September 25, 2025

Honorable Chair Robin Kramer and  
Members of the Zoning Board of Appeals  
Village of Mamaroneck  
169 Mount Pleasant Avenue  
Mamaroneck, NY 10543

Re: Appeal of Issuance of Building Permit  
1011 Greacen Point Road, Mamaroneck, NY

CLIENT/ADDRESS: VALLES-MOELIS RESIDENCE 1011 GREACEN POINT ROAD MAMARONECK, NY 10543	
ISSUE: AMENDED SUBMISSION 08.20.2025	
DRAWN BY: BP CHECKED BY: DL	
TITLE: BUILDING SECTIONS	
STAMP AND SIGN.	
DRAWING NO. <b>A-3.1</b>

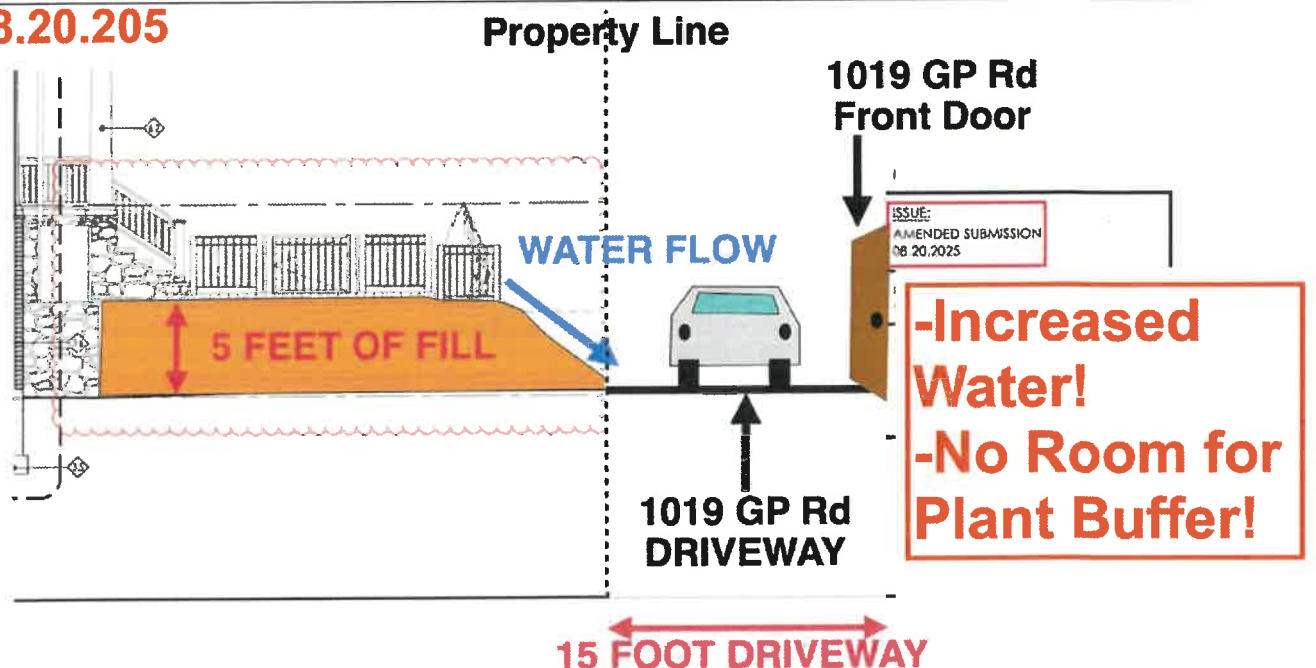
**PROPOSED NEW GRADE CHANGE**  
rev. 08.20.205

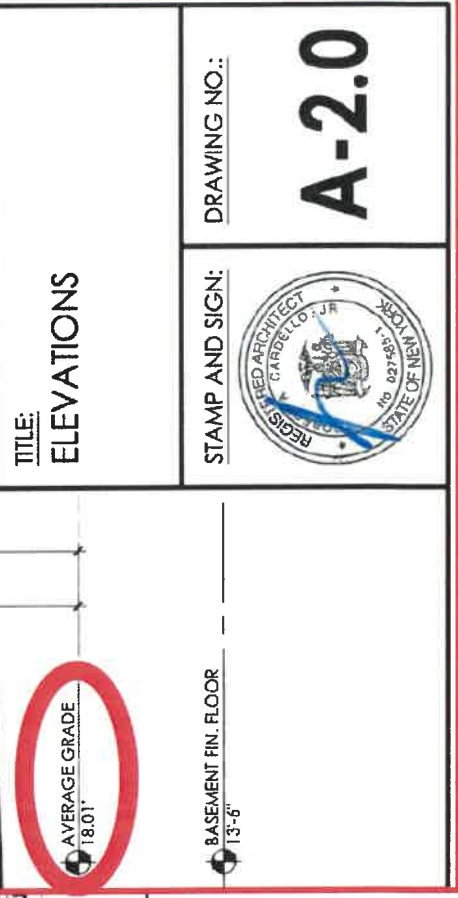
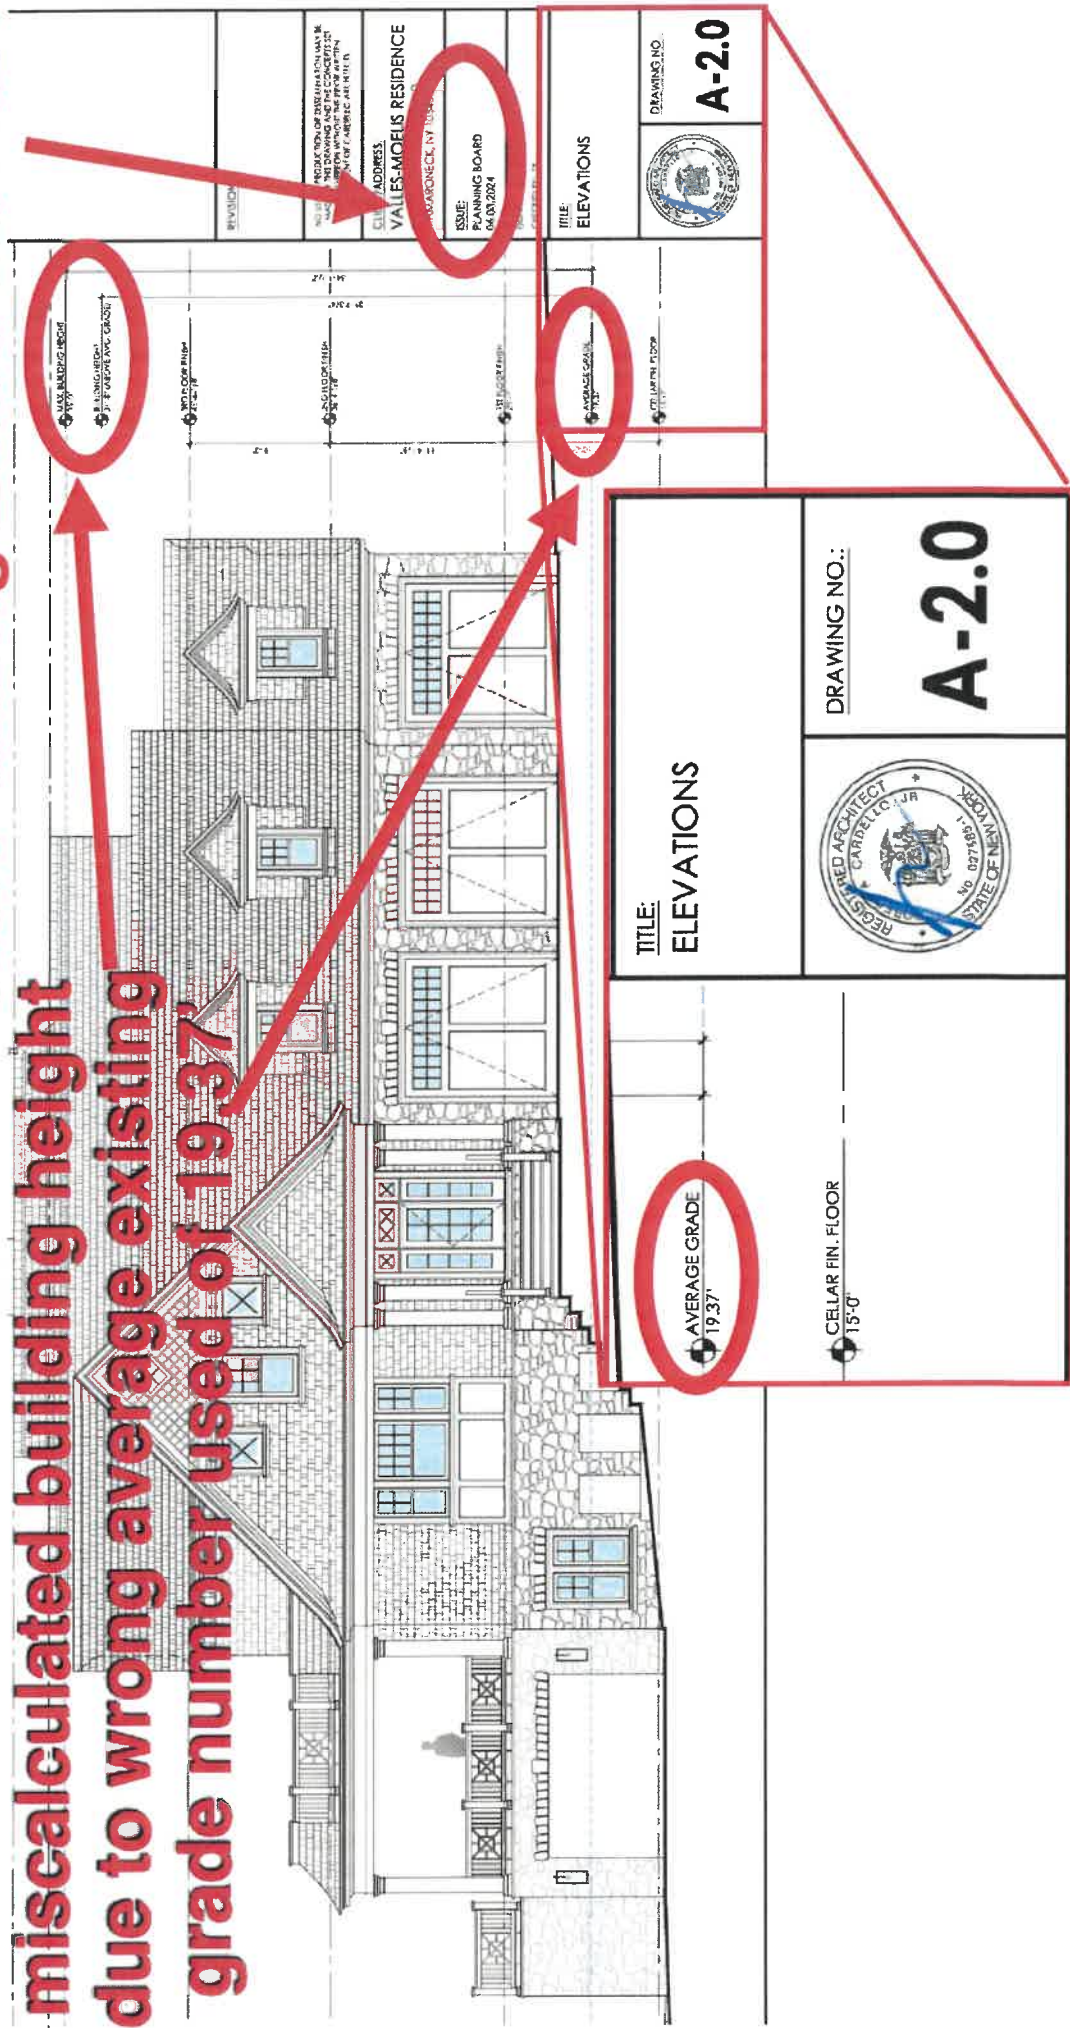
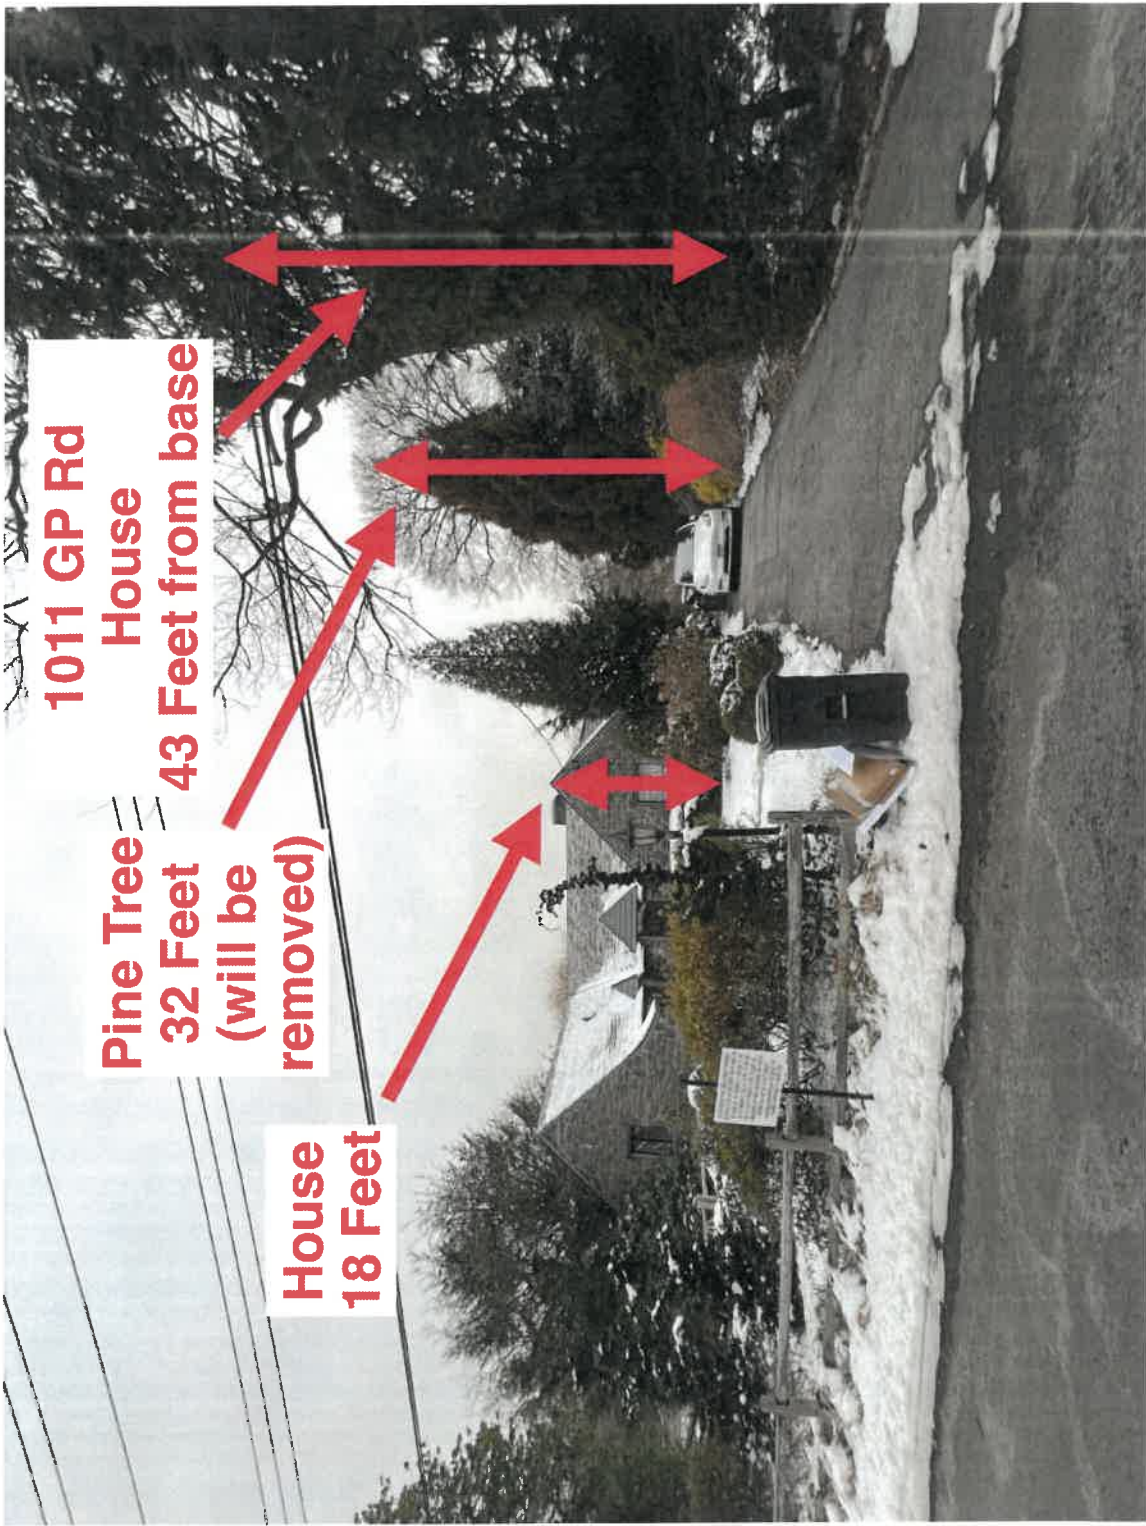
**miscalculated building height  
due to wrong average existing  
grade number used of 18.01'**

**miscalculated building height  
due to wrong average existing  
grade number used of 19.37'**

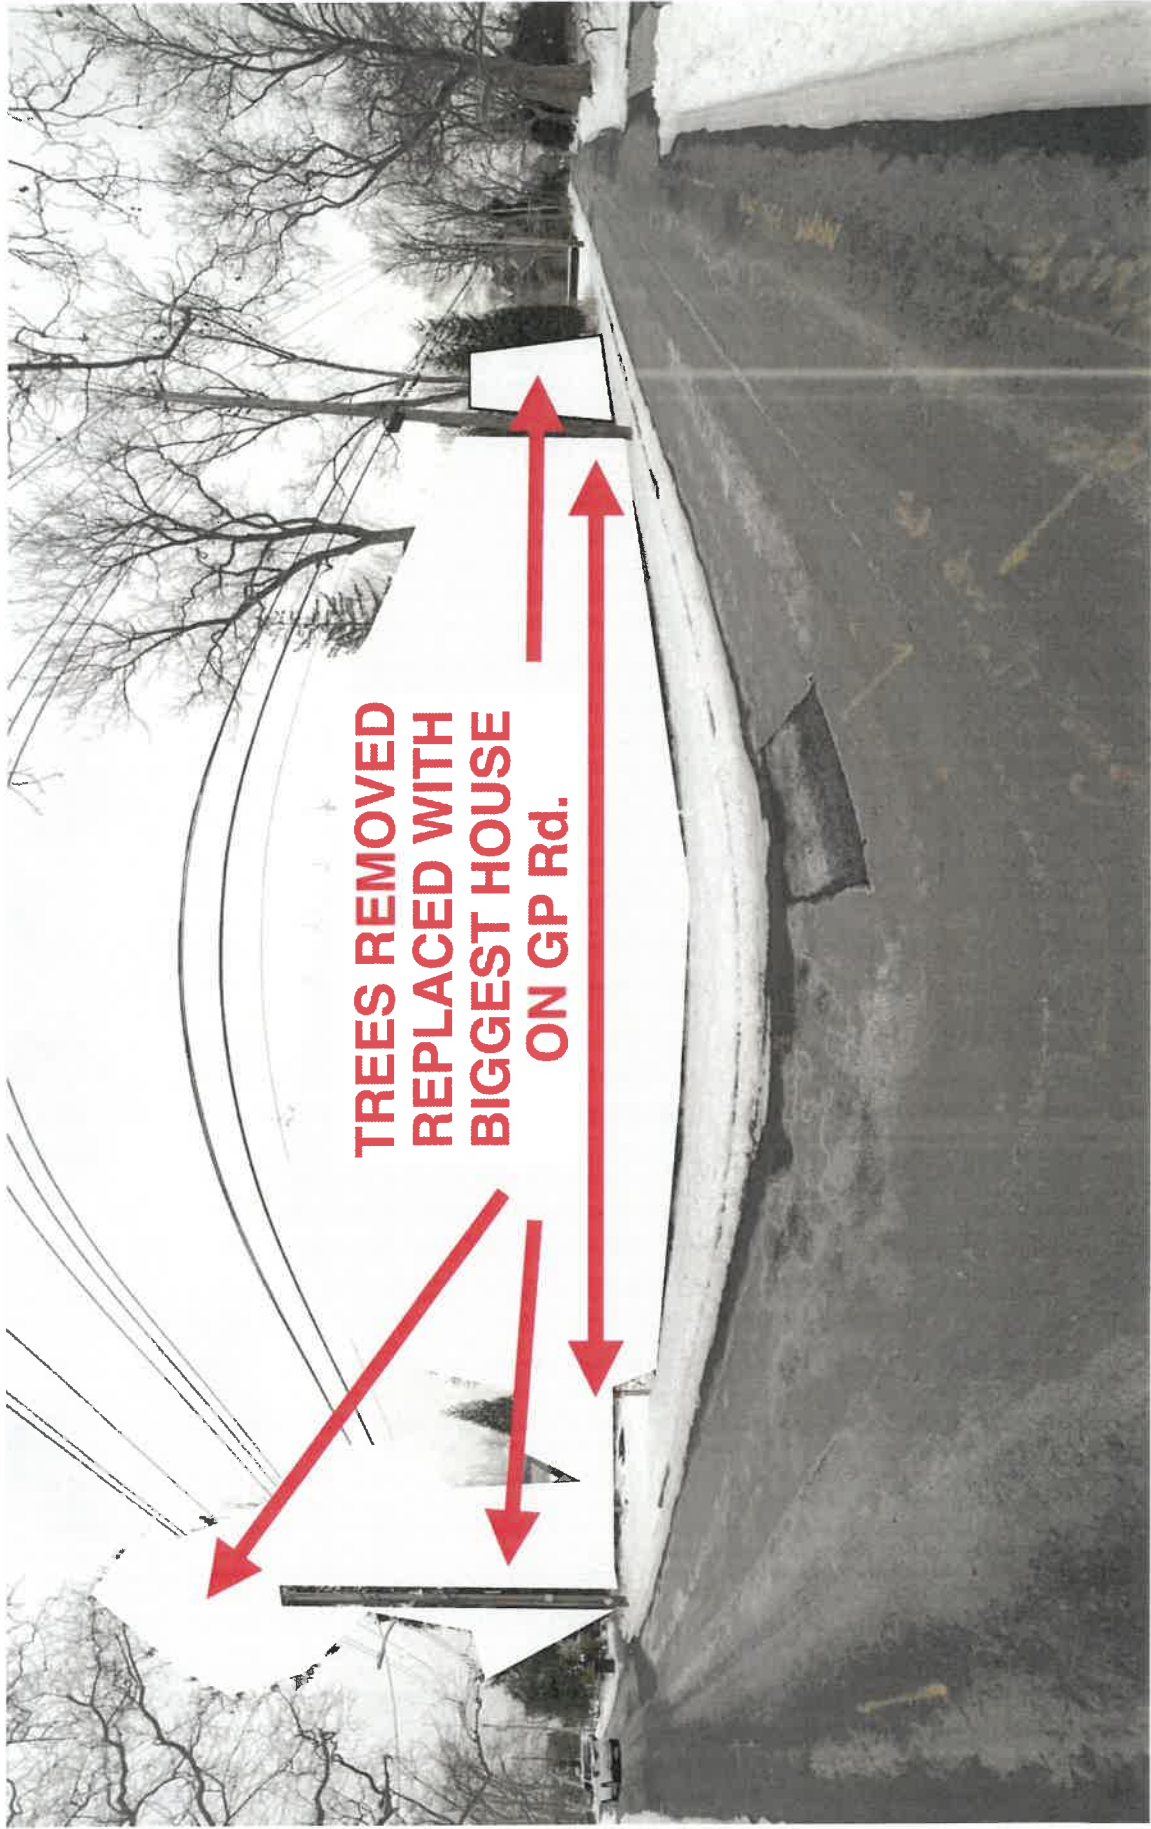
**TREES REMOVED**

**REPLACED WITH ROOF  
OF NEW 1011 GP Rd**

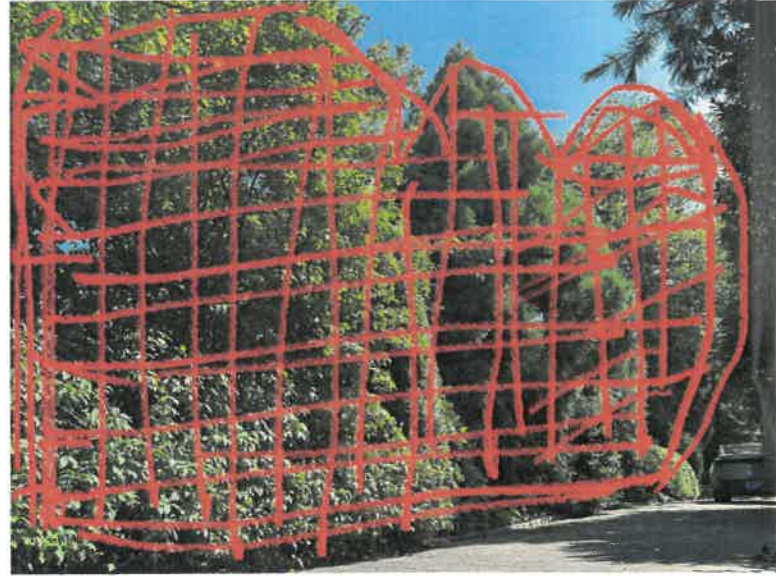
**RED CROSSHATCH = planned cutting of existing mature evergreen and deciduous buffer. Our 1019 driveway. Car parked next to main use door, mid driveway as exists now. Photo taken**

**RED CROSSHATCH = planned cutting of existing mature evergreen and deciduous buffer and other trees nearby. Existing evergreen and deciduous mature buffer along Southern property line of 1011, taken from public road in front of Southern part of 1011. Photo taken Sunday 9/7/25.**

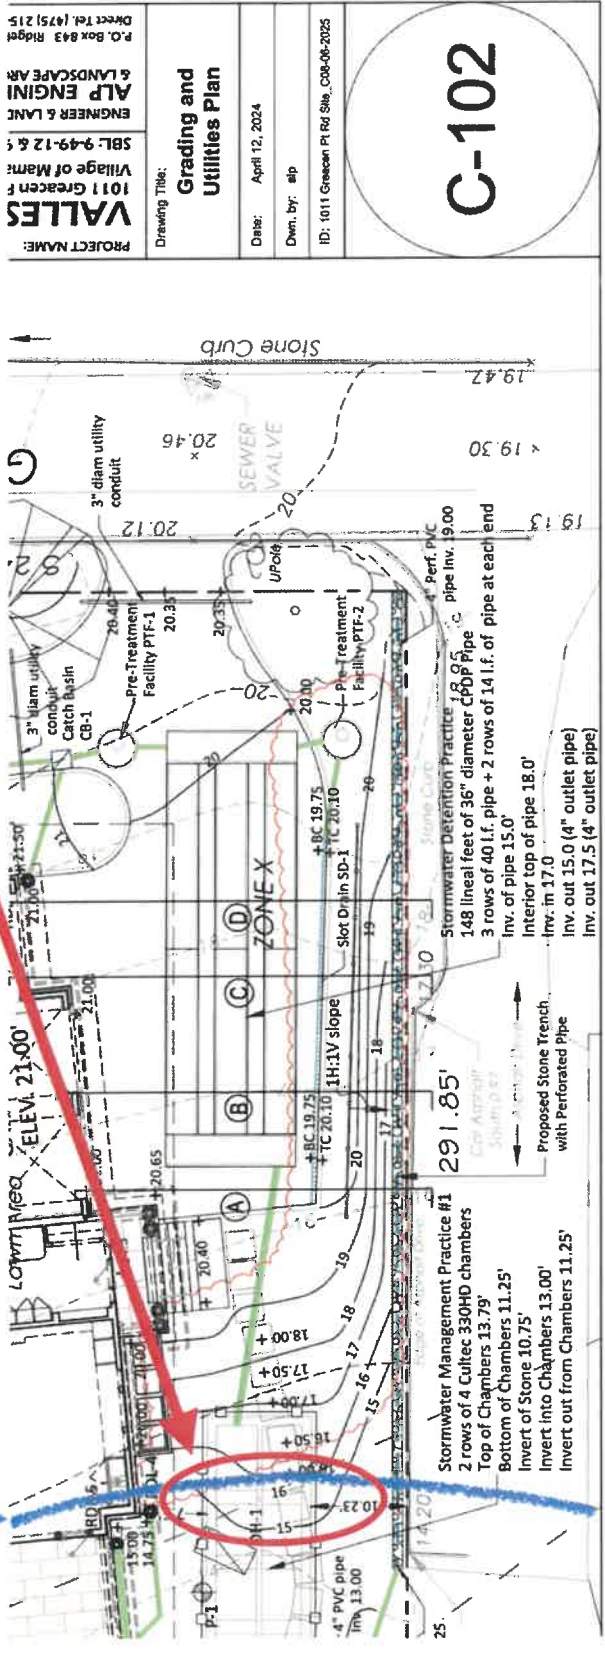
Latest plans show new fill and grading in the wetland buffer, requiring a new wetland permit.

Blue line:  
VOM Wetland Buffer
